**RE: Chick-Fil-A @ Coors Pavilion – Additional Parking Lot  
4001 Coors Blvd NW  
Conceptual Grading & Drainage Plan  
Engineer's Stamp Date: 06/28/22  
Hydrology File: G11D069C**

Based upon the information provided in your submittal received 06/30/2022, the Conceptual Grading & Drainage Plan **is not** approved for action by the DRB on Site Plan for Building Permit. The following comments need to be addressed for approval of the above referenced project:

SHEET TITLE  
GRADING AND  
DRAINAGE PLAN

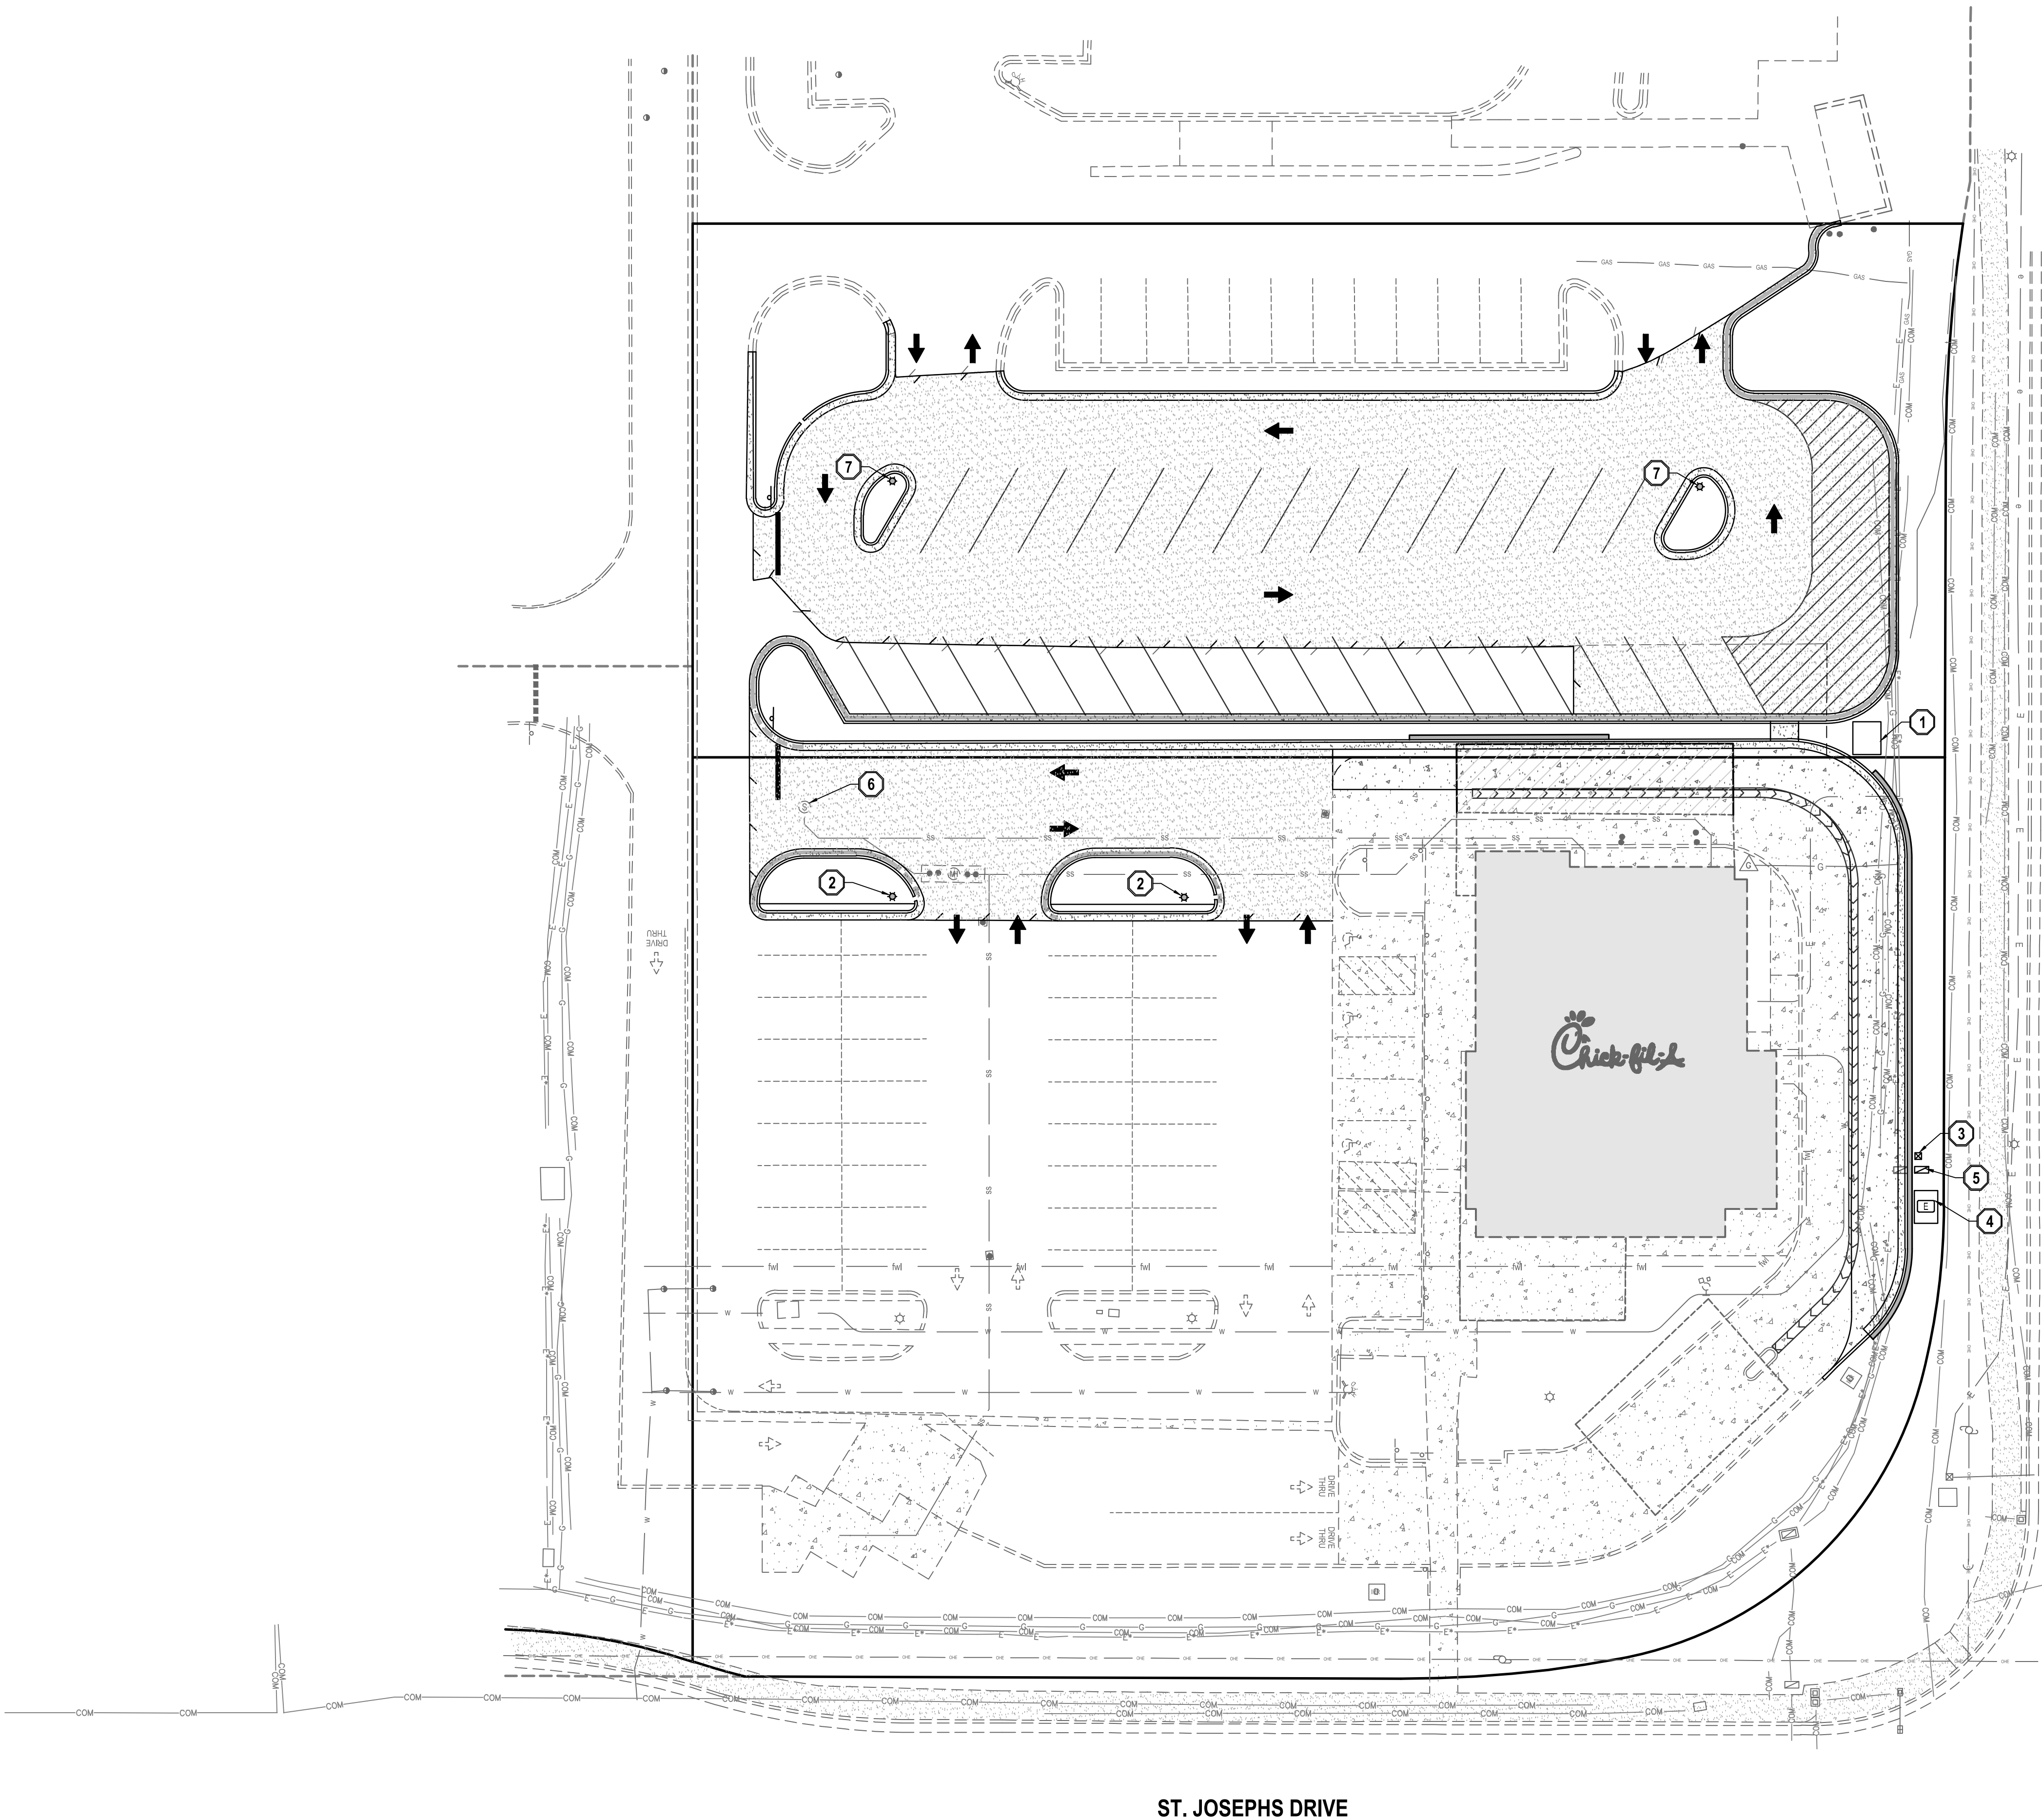
1. Under Existing Conditions, please refer to the Amended Master Drainage Plan dated 12/2020 by Respec. Lot 5 (which the project is on) has a designed allowable discharge of 2.90 cfs which was designed to go directly north into Lot 4 but could be discharge into the private access / drainage easement which ultimately discharges into the Coors Pavilion detention pond.

2. Please use the procedure for 40 acre and smaller basins as outlined in Development Process Manual (DPM) Article 6-2(a). Please provide both the existing conditions and proposed conditions for the 100 year-6 hour storm event. Please show the calculations per the DPM and not just the end result.

3. Please follow the DPM Article 6-12 Stormwater Quality and Low-Impact Development for the sizing calculations. To calculate the required SWQV, multiply the impervious area draining to the BMP by 0.42 inches for new development sites.

4. Please provide the SWQV calculations for each basin draining to each pond. The stormwater quality ponds need to be sized for the areas draining to them.

5. Please label the size of each curb cut and please provide the weir calculations, per DPM Article 6-16(A), for the curb cuts. A coefficient of 2.7 is typically used for the weir equation  $Q = CLH^{2/3}$ .

6. Not sure where the drainage from Basin 2 (the new drive lane) is going. This drainage cannot go directly into Coors Blvd. This is not allowed. I do not see how this is directed towards the interior private access / drainage easement.
